CFC Percy St. Auburn

13 Percy Street, Auburn, NSW 2144

S4.55 - AMENDMENT LIST

ISSUE FOR S4.55

Drawing Title: Mezz 1 Floor Plan

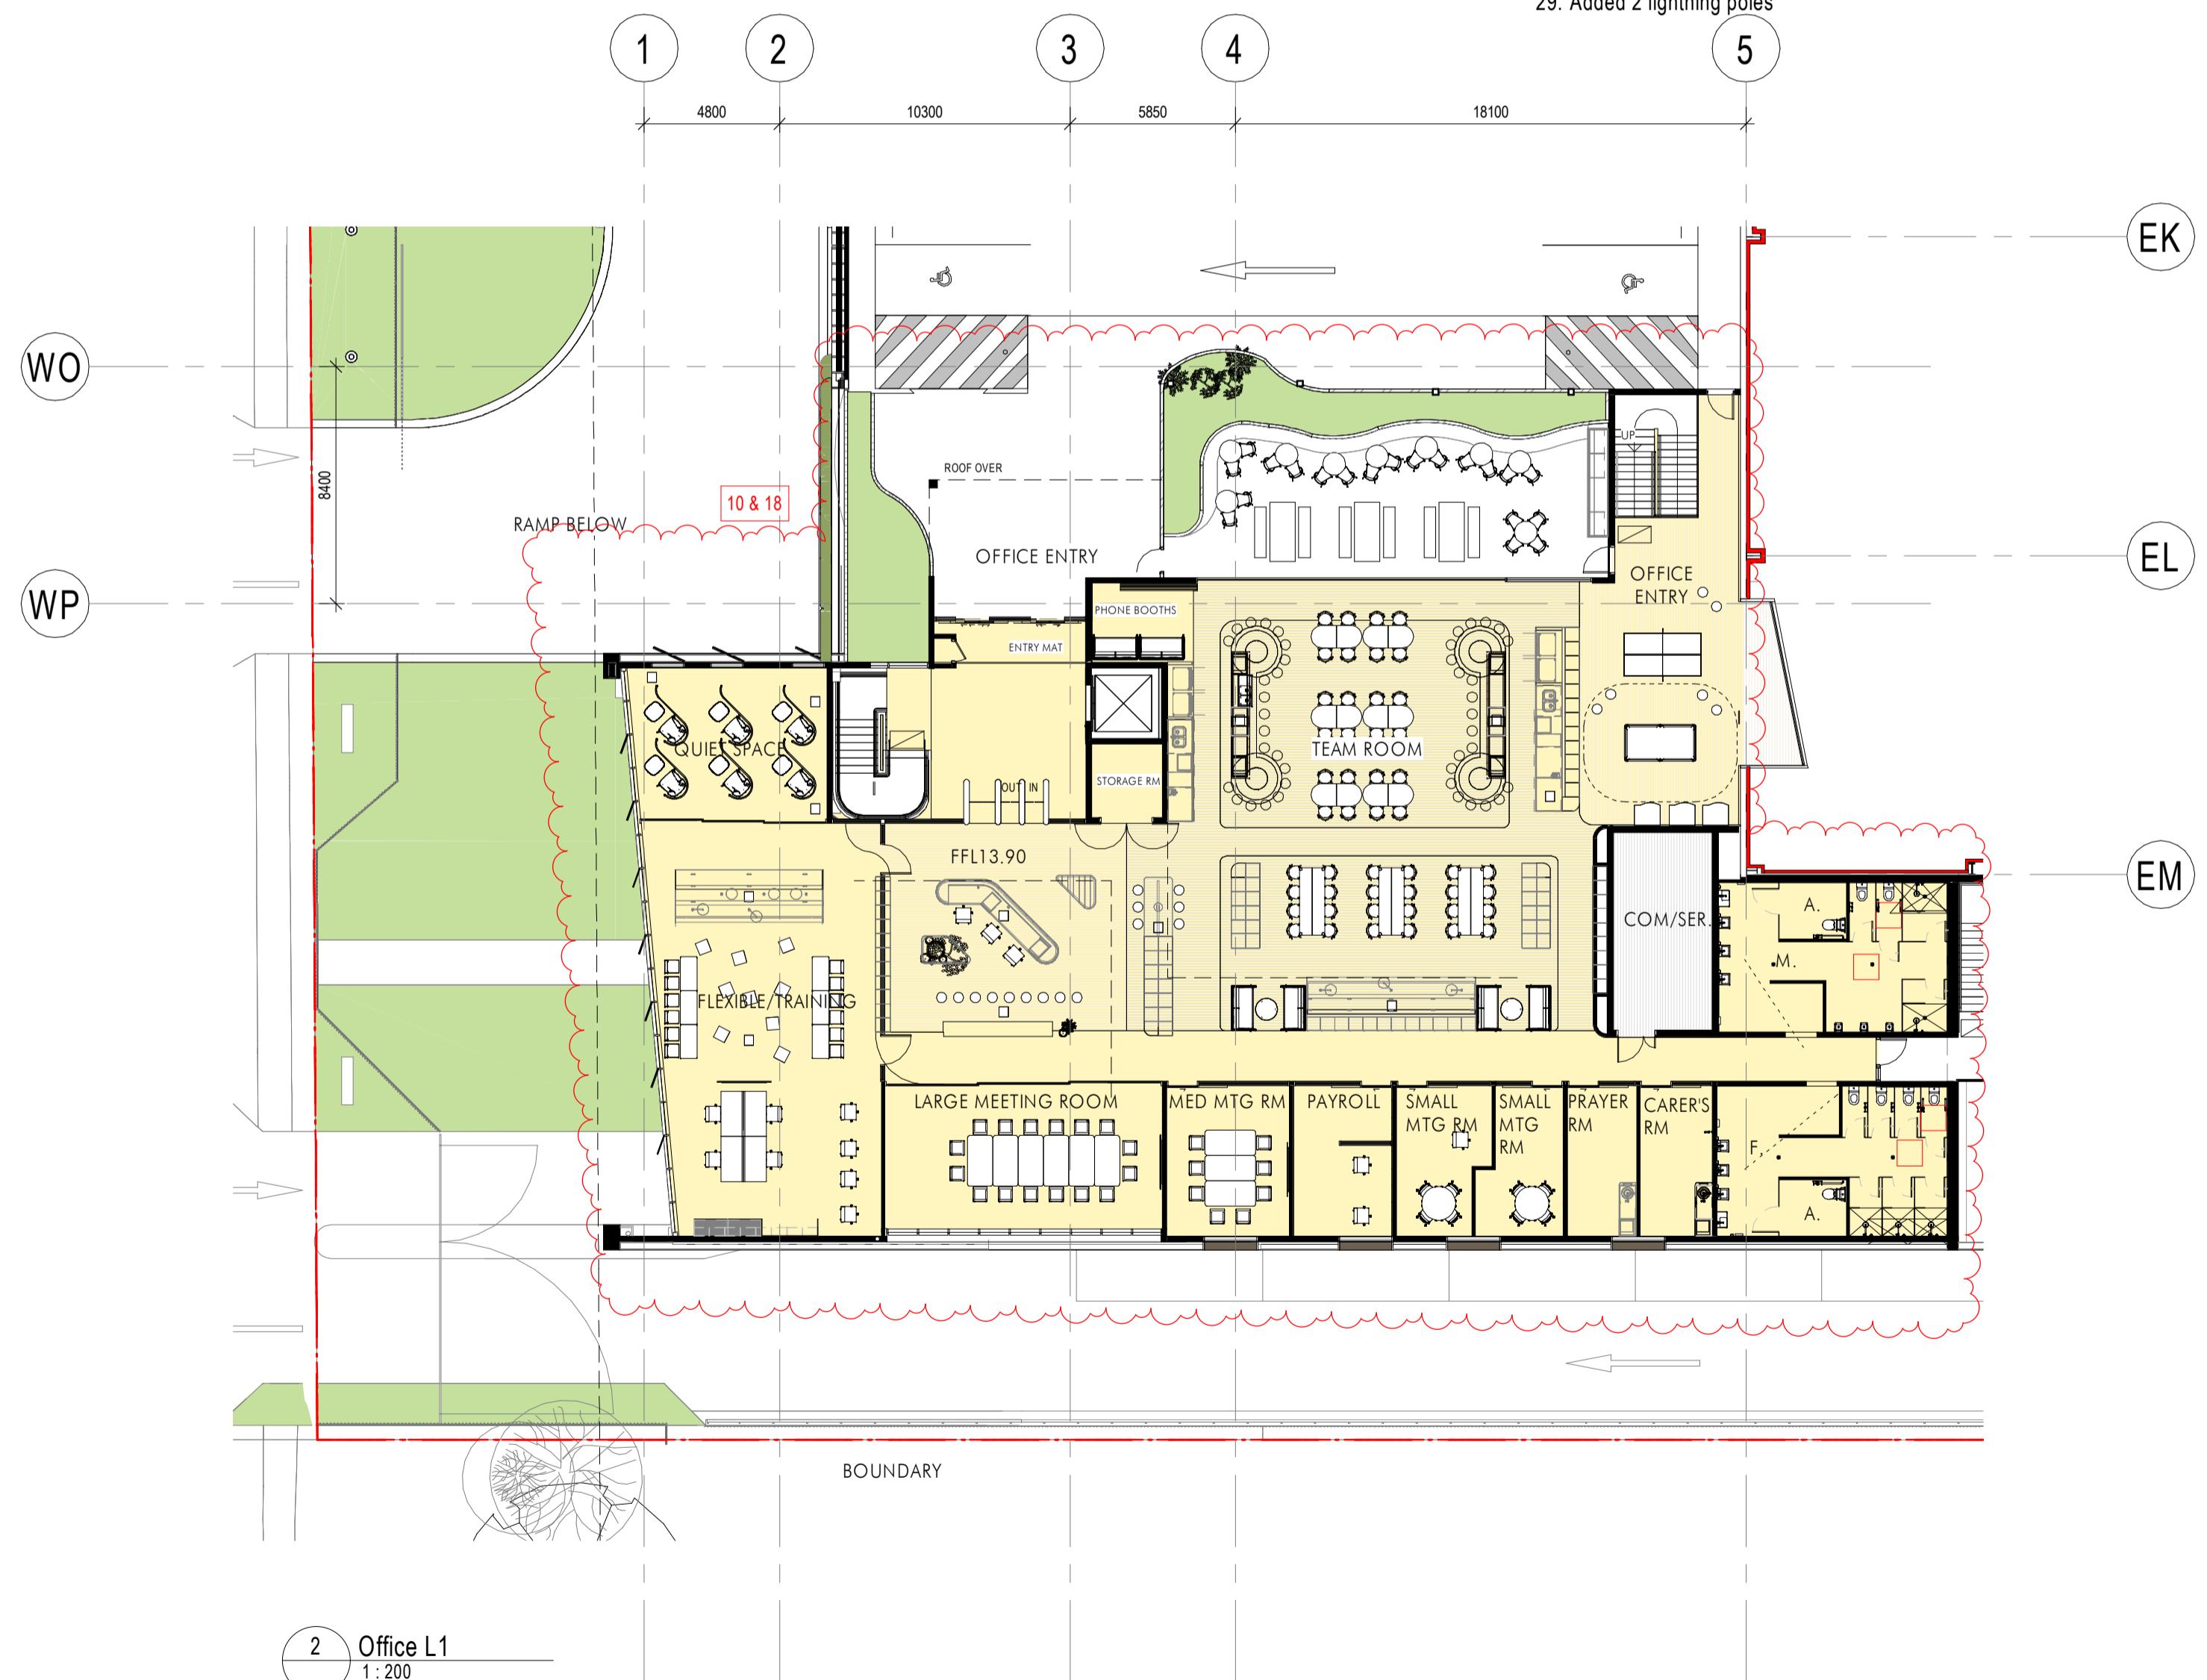
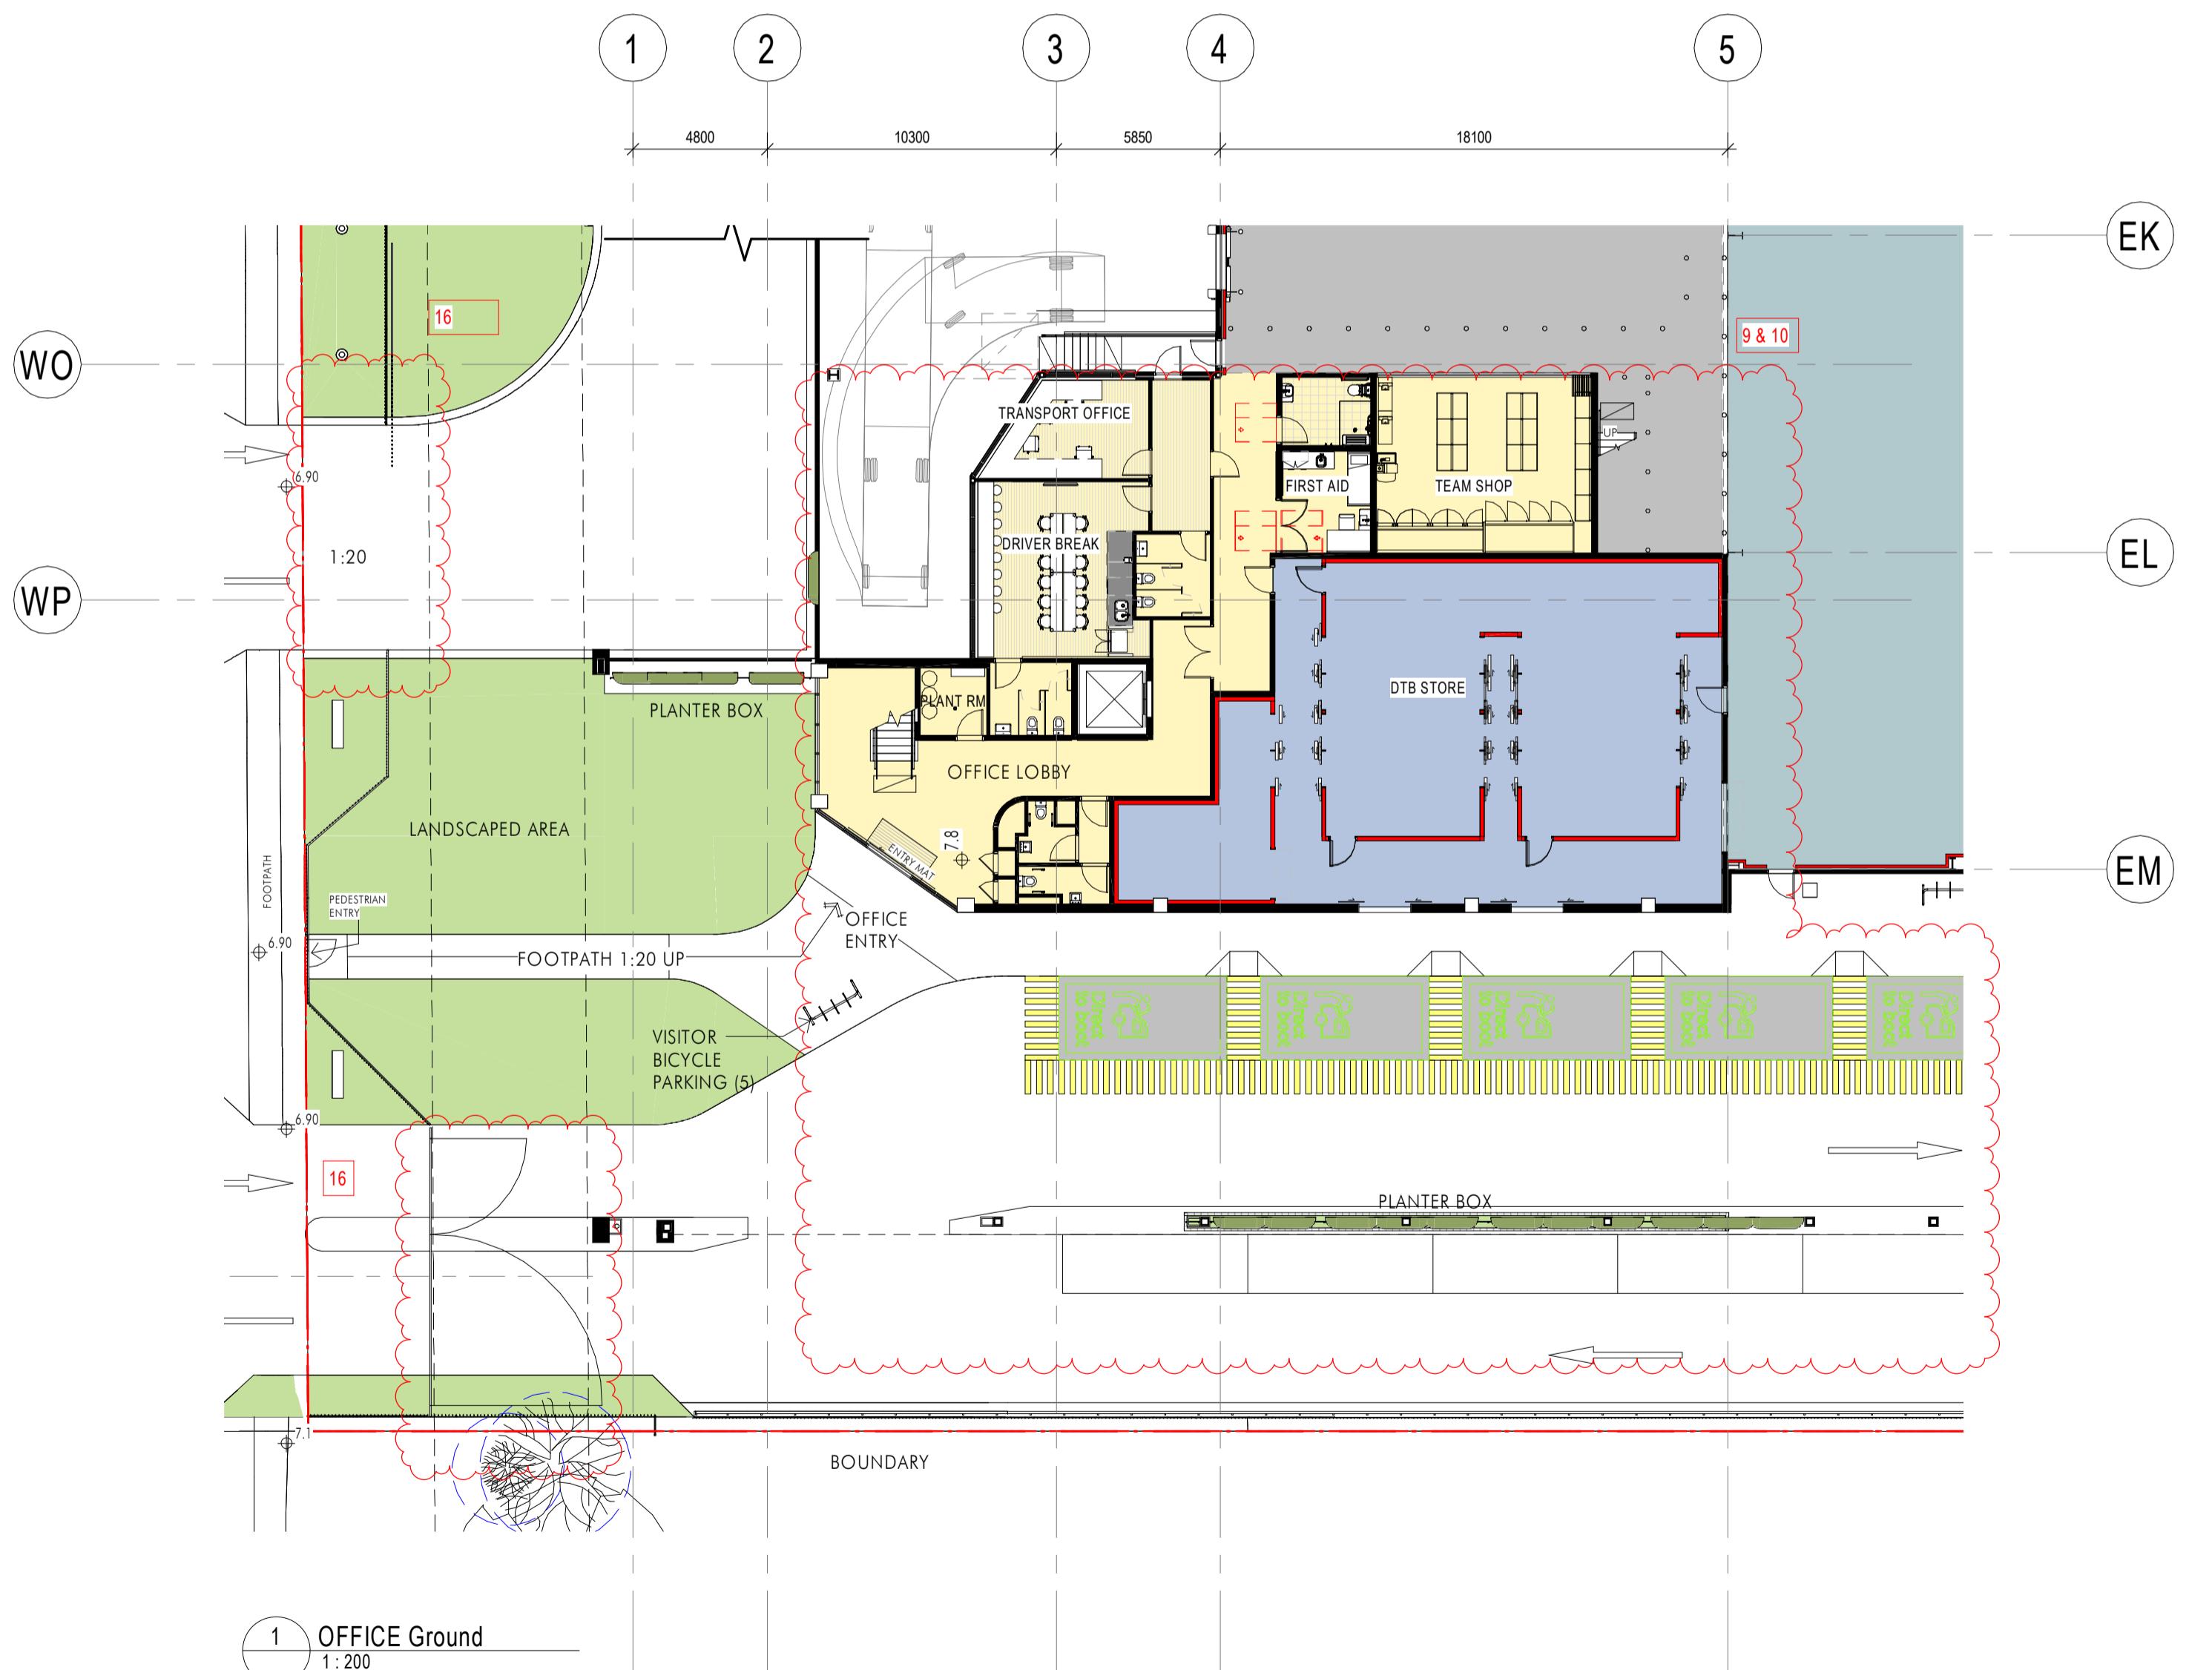
4. Added external egress stair to access mezz. floors and roof
5. Added mech. exhaust & plant on roof & removed translucent roof sheets
6. Inbound dock awning is reduced

14. Maintenance and wash bays are added
15. Added an external stair to inbound dock area
16. Security gates added
17. Boom gates added
18. Minor enlarged L1 office lobby & additional stair next to rec area

Drawing Title: Elevations - Sheet 1

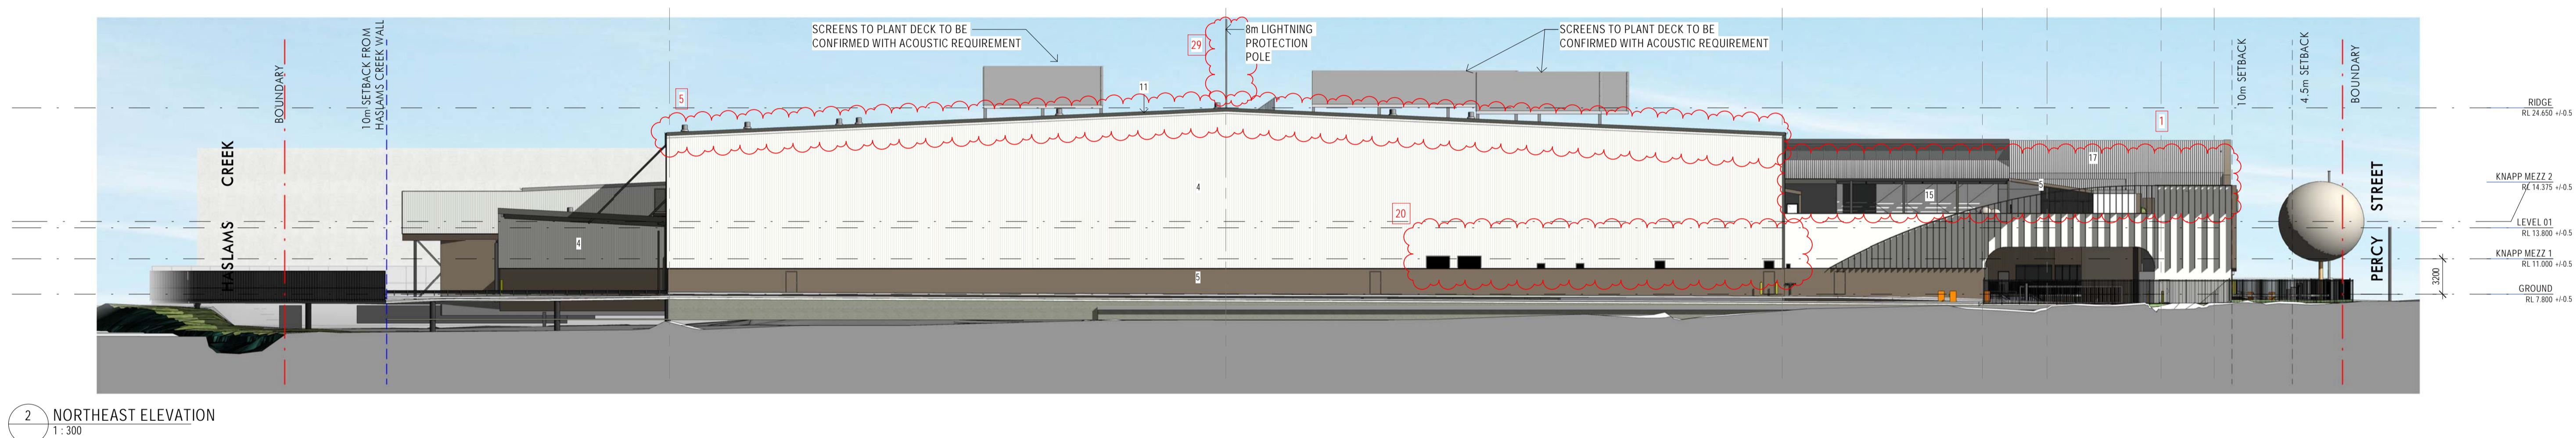
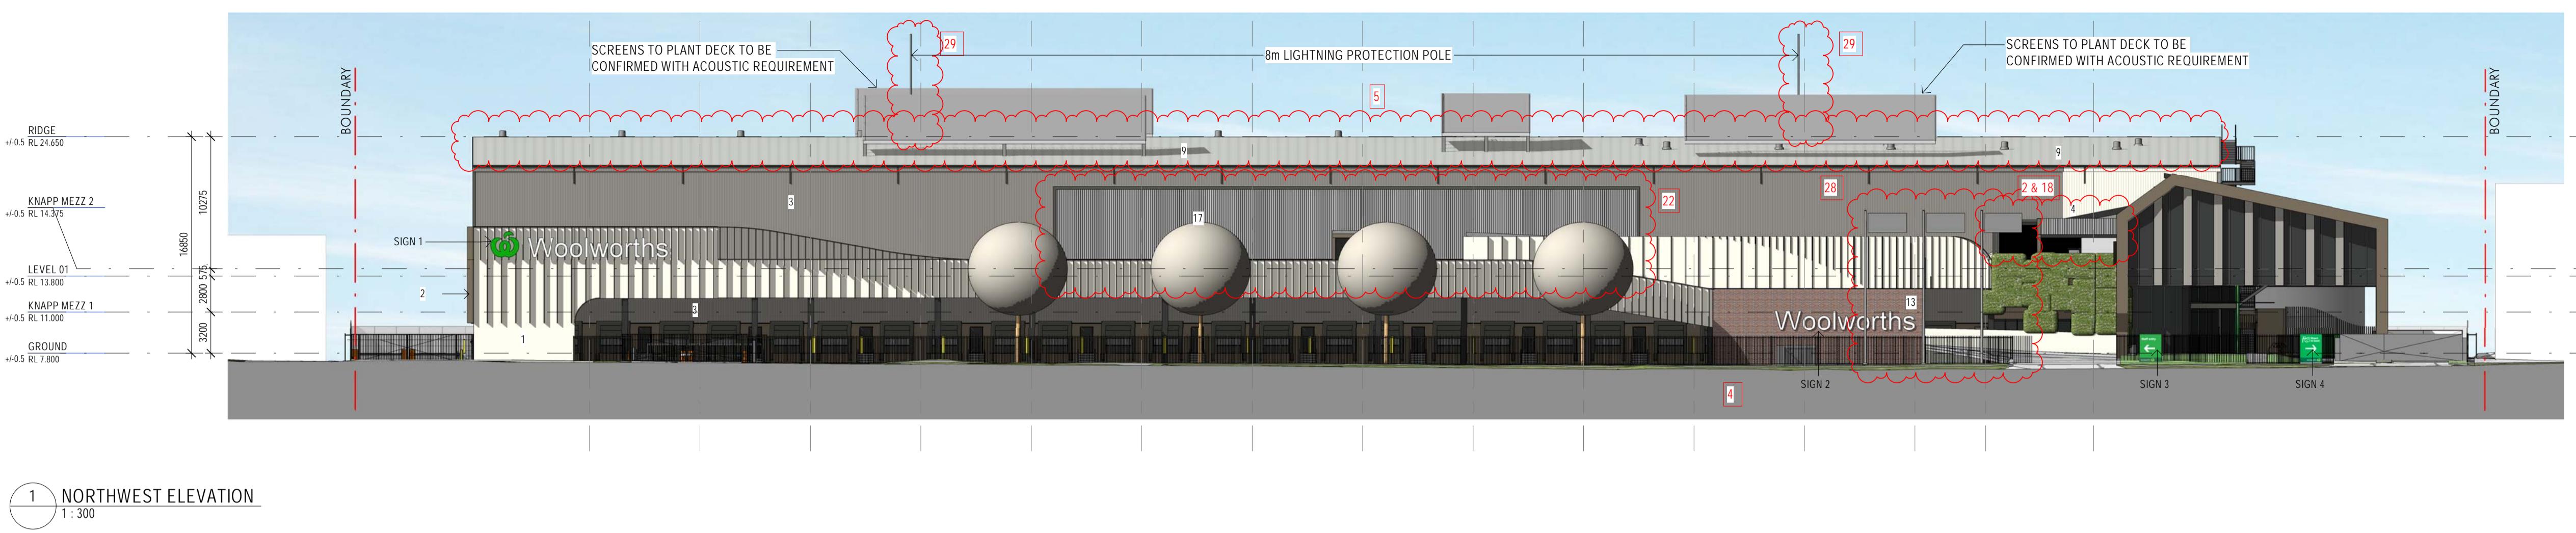
4. Added external egress stair to access mezz. floors and roof
5. Added mech. exhaust & plant on roof & removed translucent roof sheets
6. Inbound dock awning is reduced

19. NOT USED
20. Mech. Louvre added
21. Heavy duty guardrail added to suspended slab edges
22. Replaced transparent wall sheeting to Longline metal cladding

23. Pickup graphic extended
24. CFC sheeting is removed from Office ground elevation
25. NOT USED
26. Outbound Loading dock size & Van parking size increased (TBC)
